Kielty Arborist Services LLC
Certified Arborist WE#10724A TRAQ Qualified
P.O. Box 6187
San Mateo, CA 94403
650-532-4418

Site: 1385 Hillside Circle, Burlingame, CA

As requested on December 4th, 2023, Kielty Arborist Services visited the above site to provide a Tree Inventory Report/Tree Protection Plan for the proposed construction. 3 new homes are proposed for this site, and your concern as to the future health and safety of the tree has prompted this visit. Preliminary landscape plans L1 through L7 dated January 2024, lot 1 site plans A.1 through A.6 dated 10/26/22, lot 2 site plans A.1 through A.6 dated 10/26/21, and lot 3 plans A.1 through A.8 dated 10/26/21 were also reviewed for writing this report. This Tree Inventory Report is not a Tree Risk Assessment. As such, no trees were assessed for risk in accordance with industry standards, nor are there any tree risk ratings or risk mitigation recommendations provided within this preservation plan.

Showing portion of driveway recommended to be retained until the landscape phase of the project.

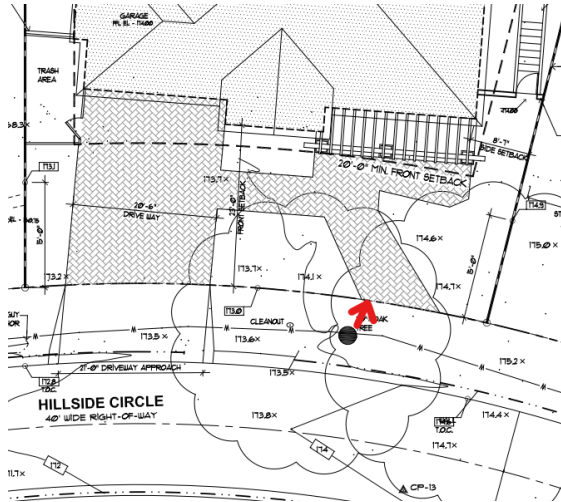
Oak tree #1 is to be retained. The tree is adjacent to an existing driveway. It is recommended to temporarily retain the existing driveway near this tree when underneath the dripline of the tree during the building phase of the project. Temporarily retaining the driveway will act as a tree protection measure and will help to increase staging and access to the site, as removing the driveway at the beginning of the project would make for a larger tree protection zone needed with the fencing being located at the tree's drip line. The existing grade within the tree's dripline is recommended to be retained as is where possible. No grading or excavation is recommended to take place within 10' from this tree (6x diameter) except for the removal of the driveway. At the end of the project, when it is time to demolish the existing driveway near this tree, the Project Arborist is

recommended to be on-site to document and witness the removal of the driveway. A jackhammer is recommended to be used when working within the tree's dripline to break the concrete material into hand manageable-sized pieces. Once broken down the driveway material is recommended to be removed by hand. Exposed roots during the process are recommended to be wrapped in layers of wetted-down burlap to avoid root desiccation. The existing driveway area is recommended to be filled back in once the driveway has been removed so that no roots are exposed to the elements. When backfilling the soil in this area, the area is also to be irrigated. The proposed driveway is further from the tree than the existing driveway and outside of the 10' range and is not expected to have impacts on the tree. The tree is recommended to be deep water fertilized with Nutriroot once the work near the tree has taken place as a mitigation measure for any minor impacts that may take place.

Showing the walkway at 4' from the tree

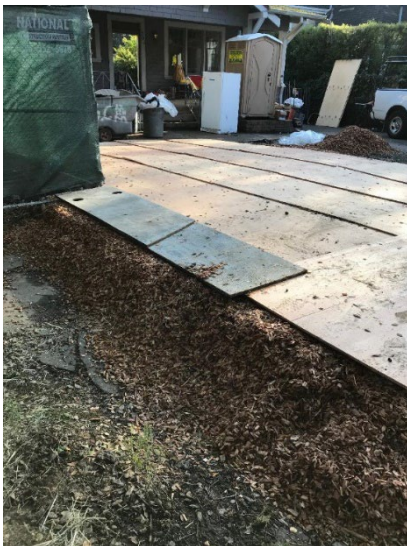
A new pathway is proposed at 4' from oak tree #10. This is too close to the tree and impacts would be expected. It is recommended to maintain a minimal clearance of 10' from the tree to the pathway to keep impacts on the tree low. With this plan change implemented, impacts are expected to be minor and will be mitigated by the recommended deep water fertilizing with Nutriroot.
